500 FAIRVIEW

MARCH 19, 2013

**PUDA REVISION
SUBMITTAL
03.19.2010**

**02.12.2013
PRE-SUBMITTAL
CONFERENCE
MEETING**

SITE PLAN IMPROVEMENTS

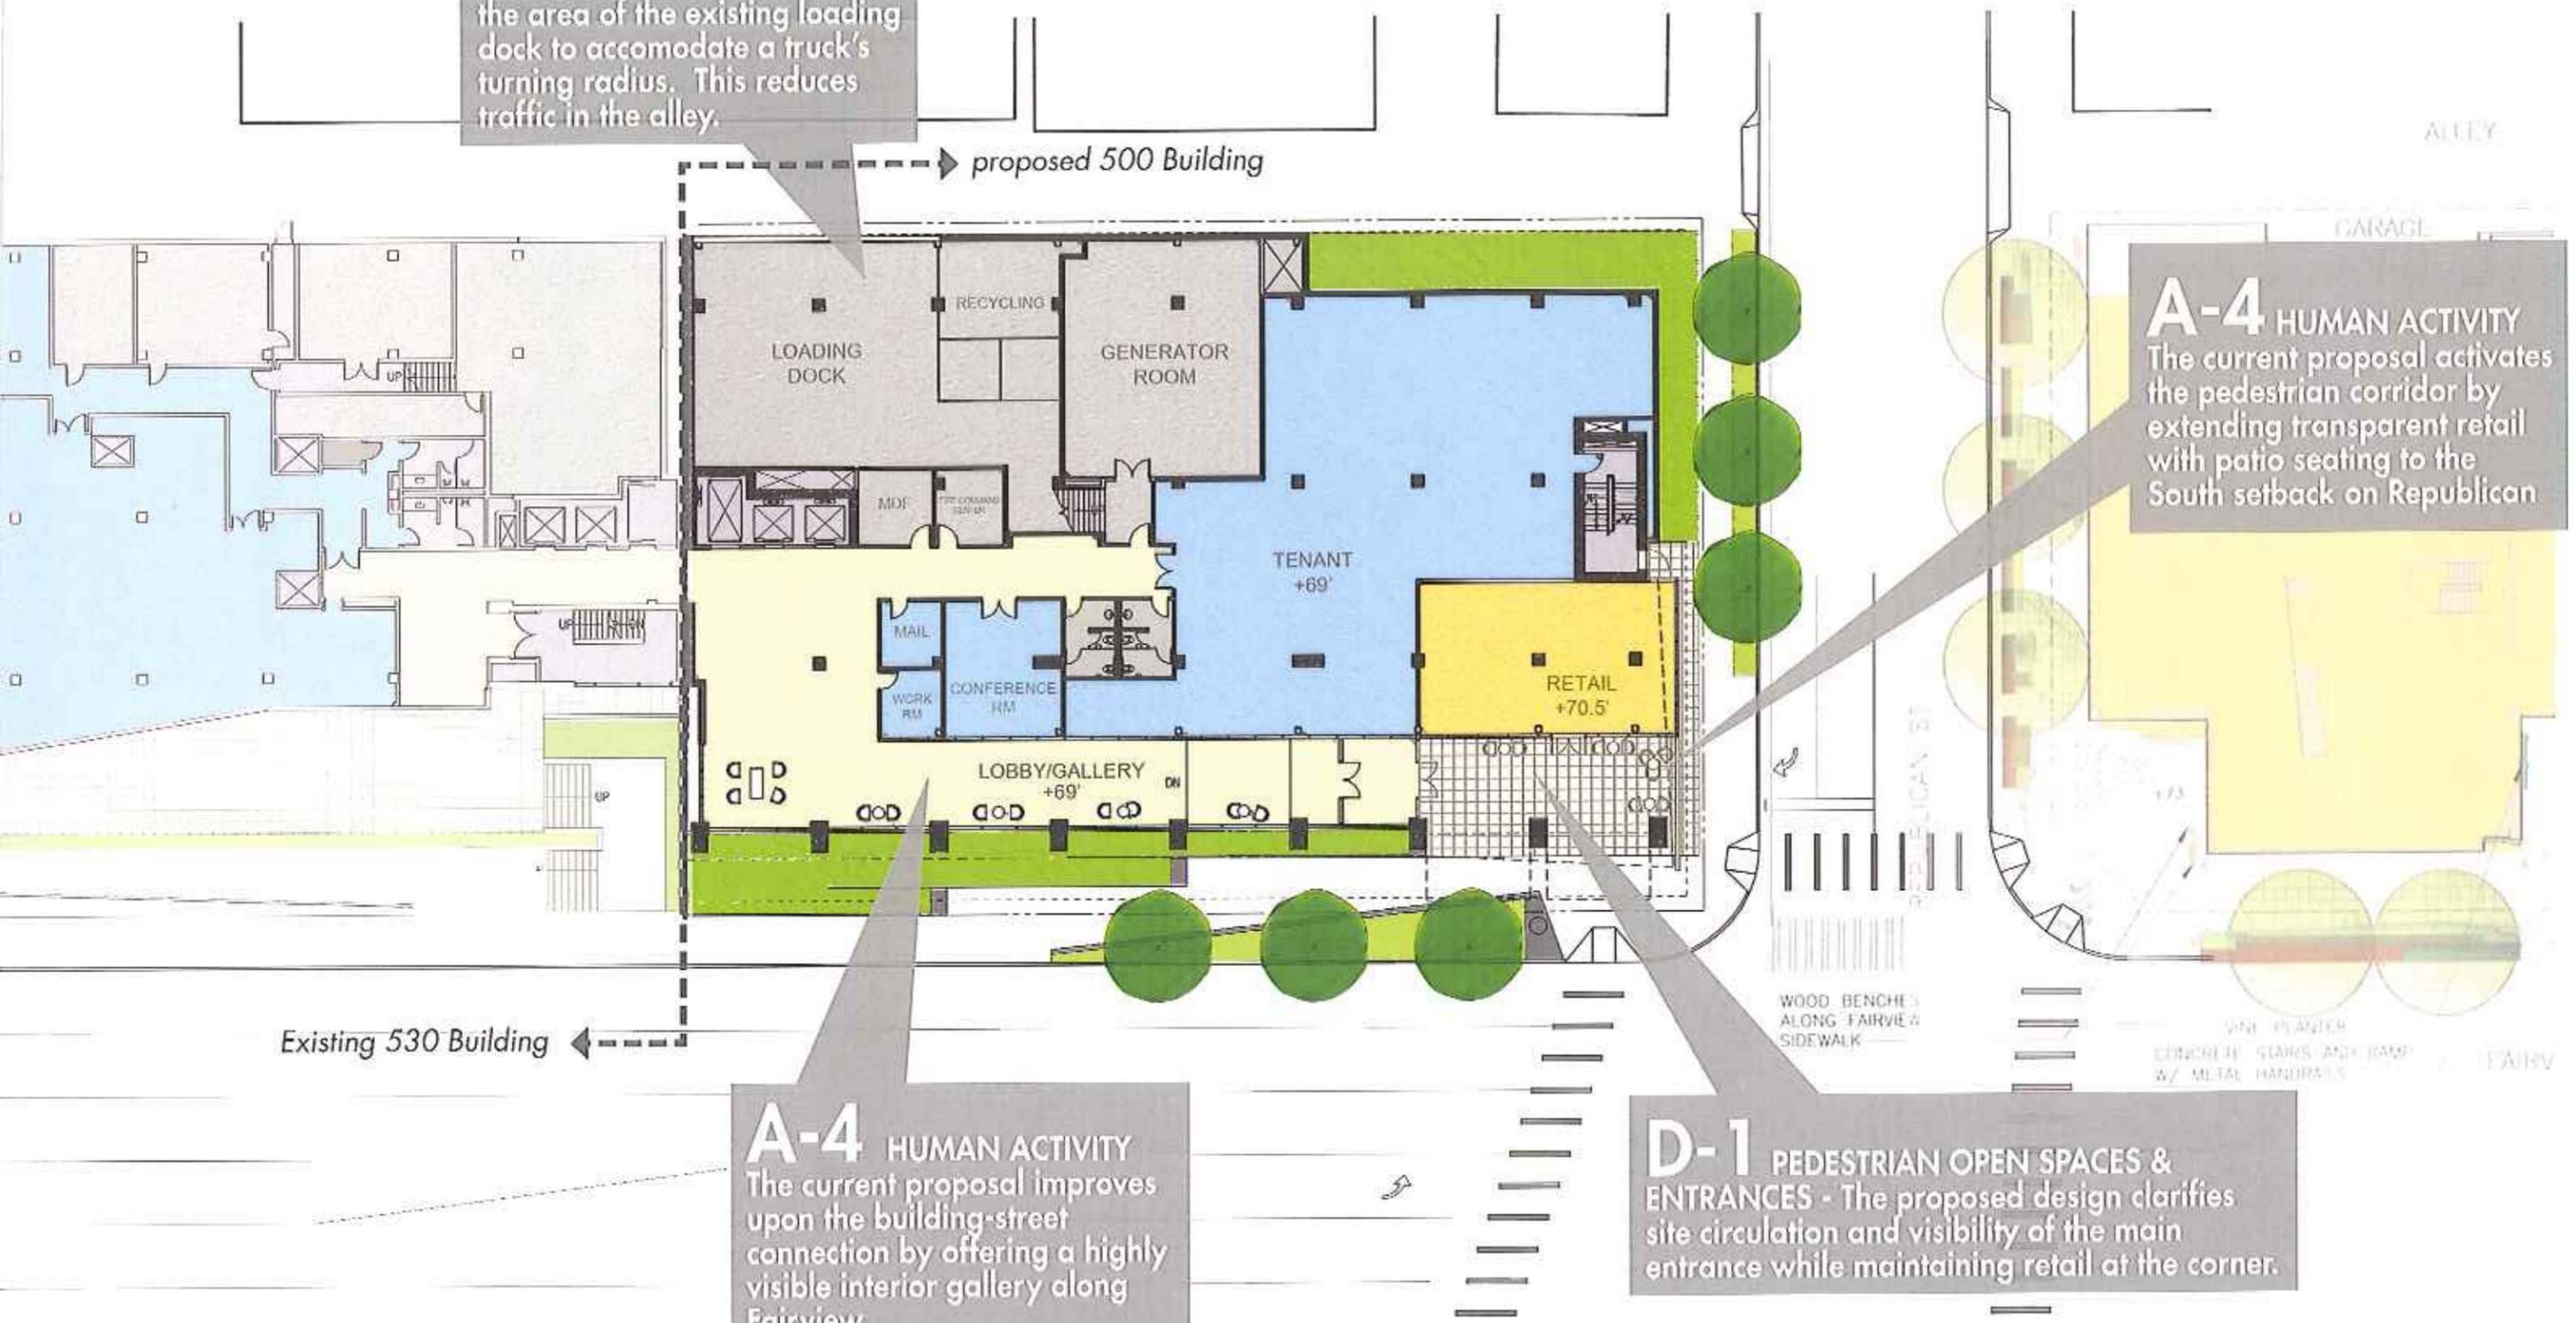
A-8 VEHICLE ACCESS
 The proposed design improves vehicle access by increasing the area of the existing loading dock to accommodate a truck's turning radius. This reduces traffic in the alley.

A-4 HUMAN ACTIVITY
 The current proposal activates the pedestrian corridor by extending transparent retail with patio seating to the South setback on Republican.

A-4 HUMAN ACTIVITY
 The current proposal improves upon the building-street connection by offering a highly visible interior gallery along Fairview.

D-1 PEDESTRIAN OPEN SPACES & ENTRANCES - The proposed design clarifies site circulation and visibility of the main entrance while maintaining retail at the corner.

LANDSCAPING IMPROVEMENTS

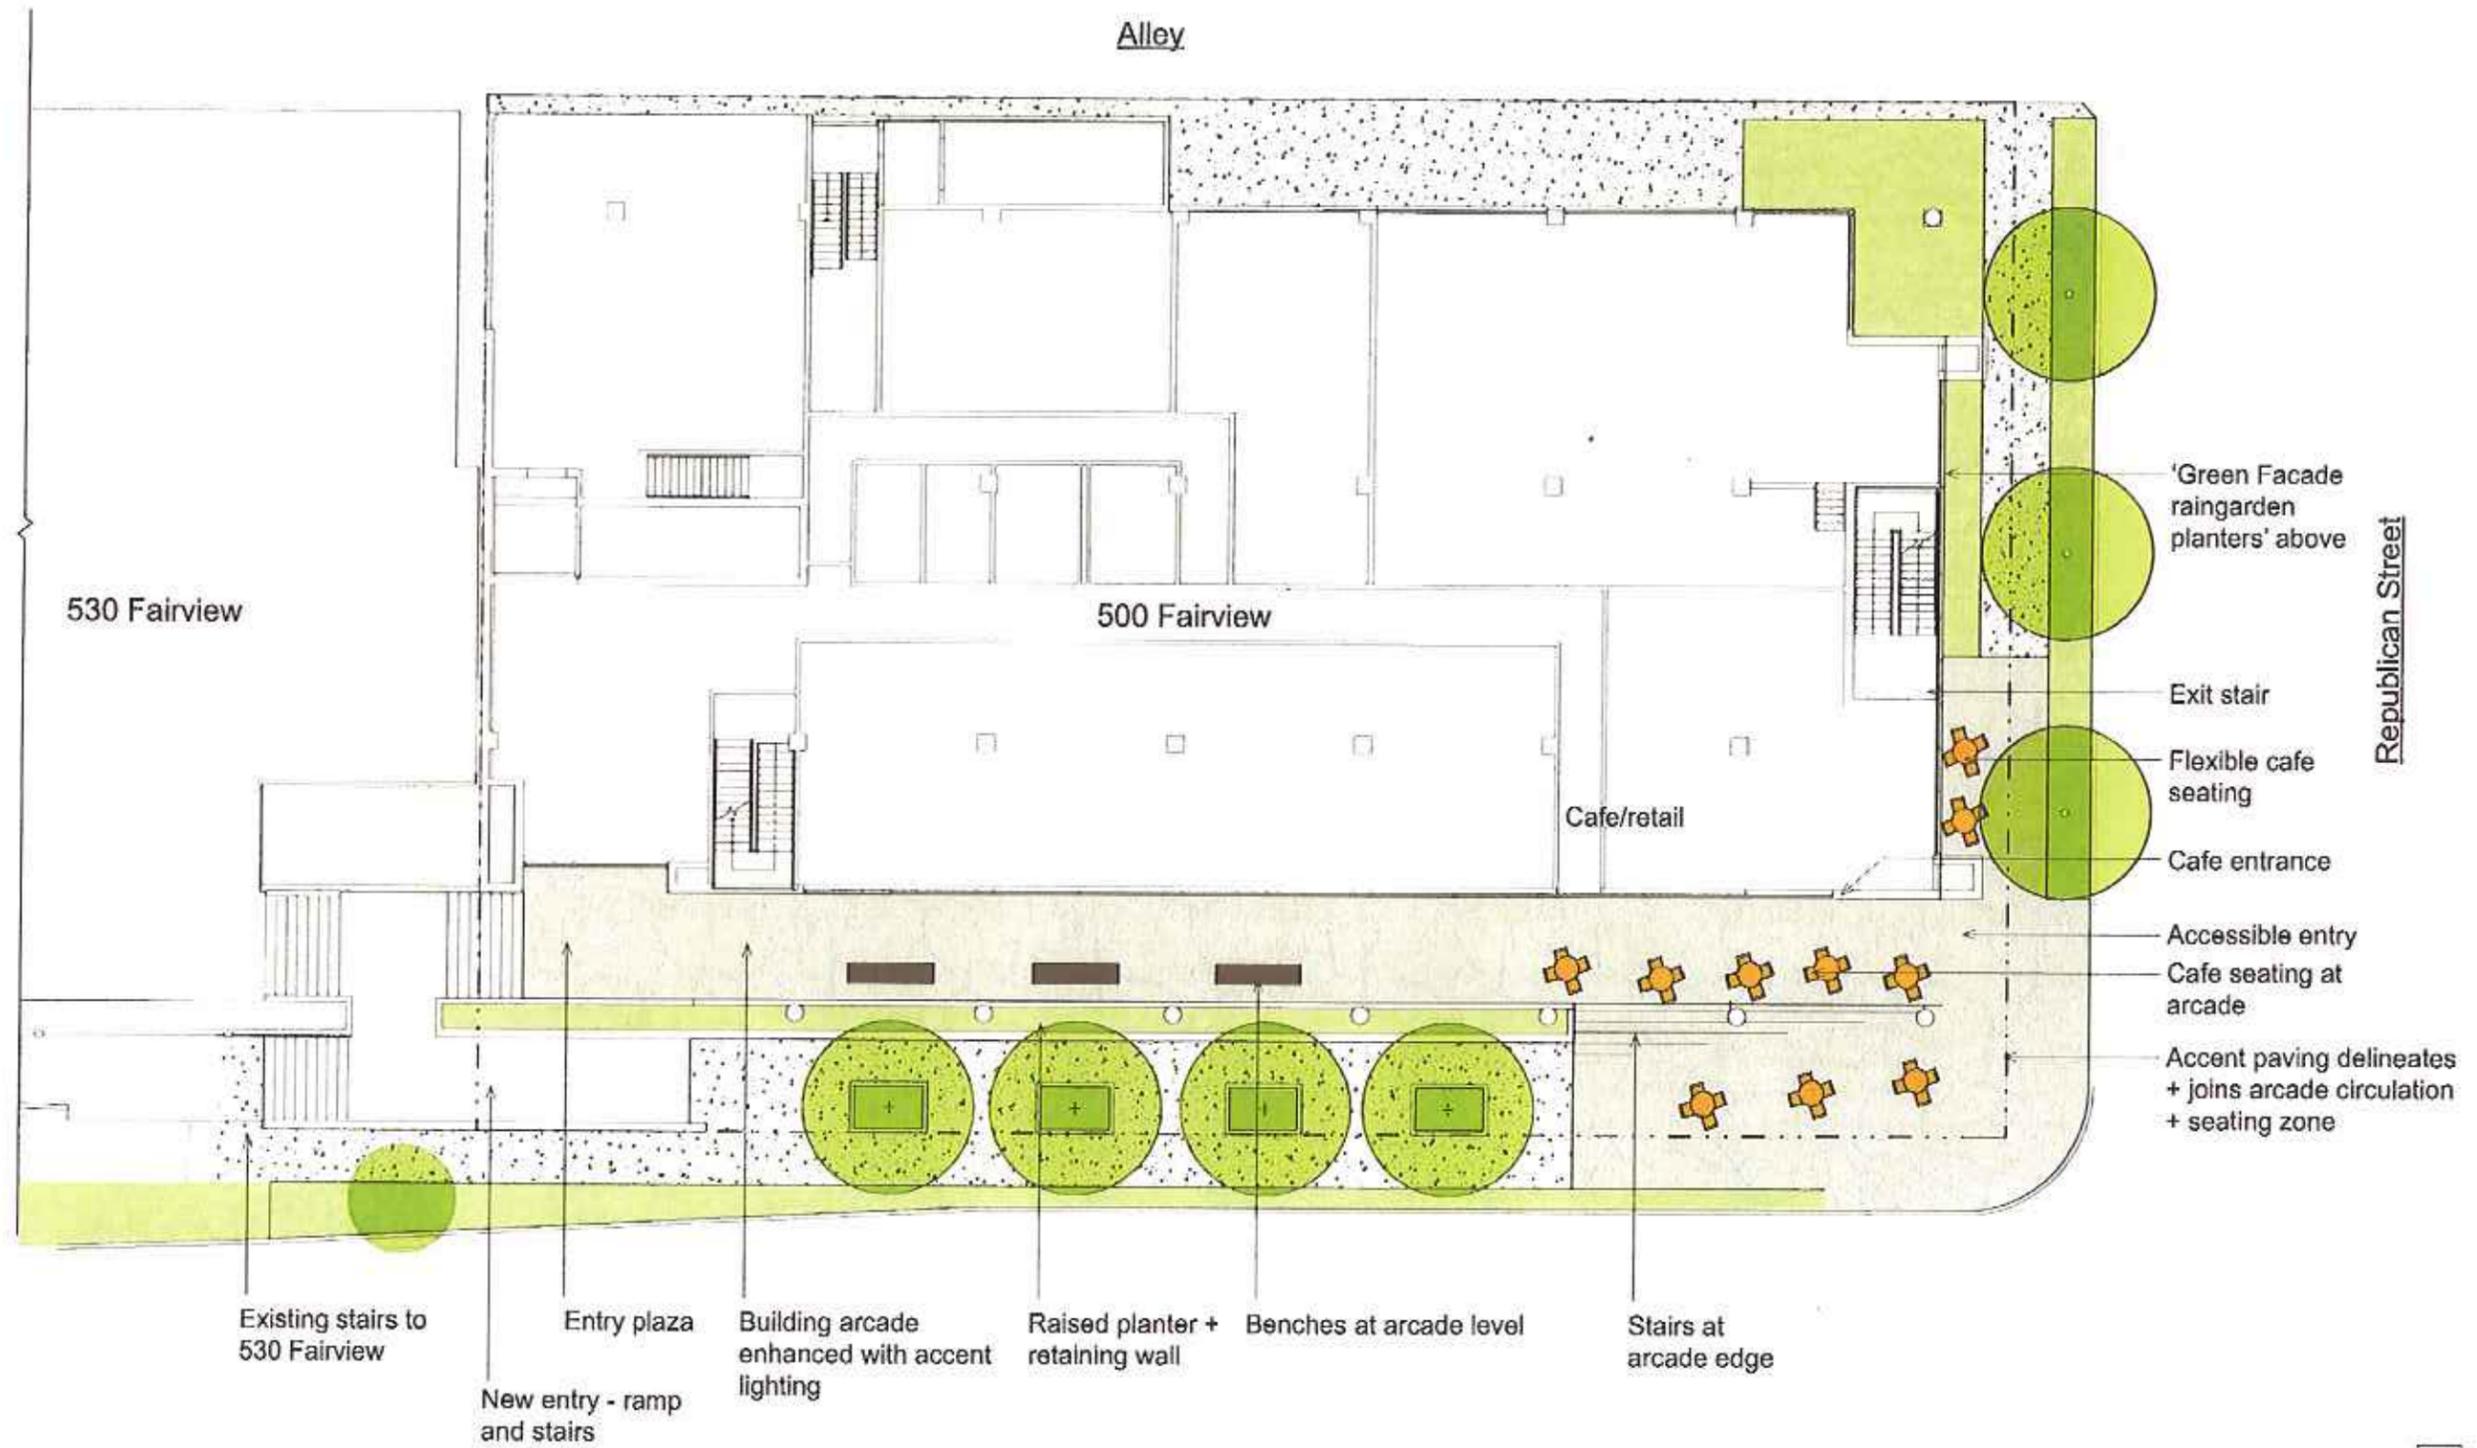
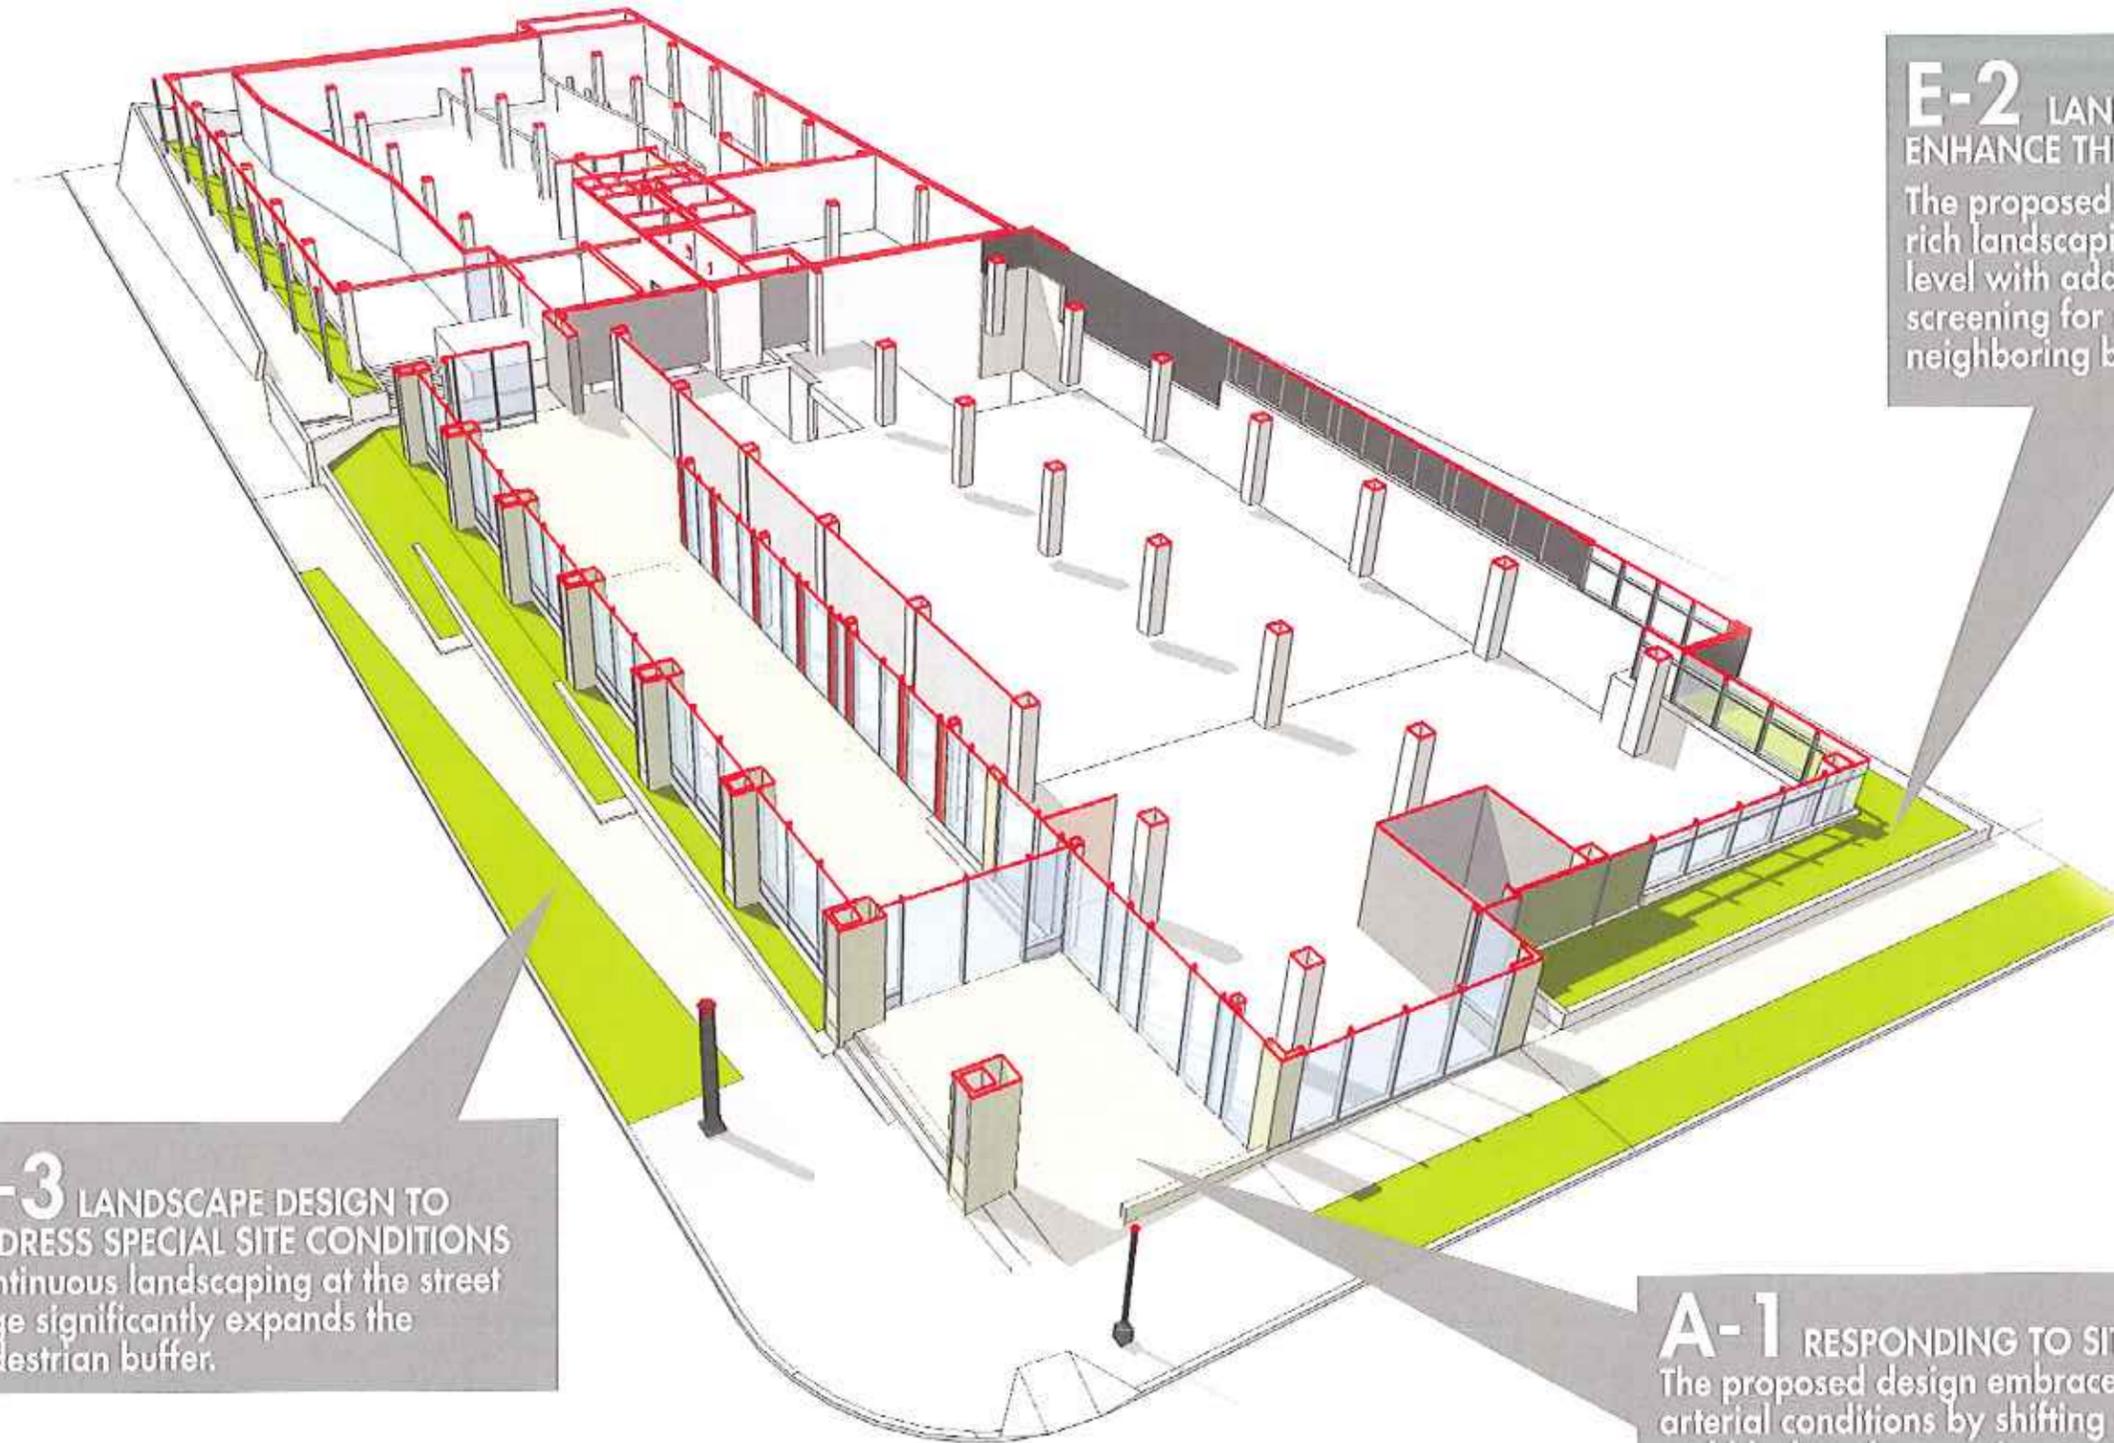
E-2 LANDSCAPING TO ENHANCE THE BUILDING AND SITE
The proposed design provides rich landscaping at the ground level with additional landscape screening for residentially-scaled neighboring buildings.

E-3 LANDSCAPE DESIGN TO ADDRESS SPECIAL SITE CONDITIONS
Continuous landscaping at the street edge significantly expands the pedestrian buffer.

A-1 RESPONDING TO SITE CHARACTERISTICS
The proposed design embraces topography and arterial conditions by shifting the main entry from mid-block to the prominent corner of Fairview and Republican.
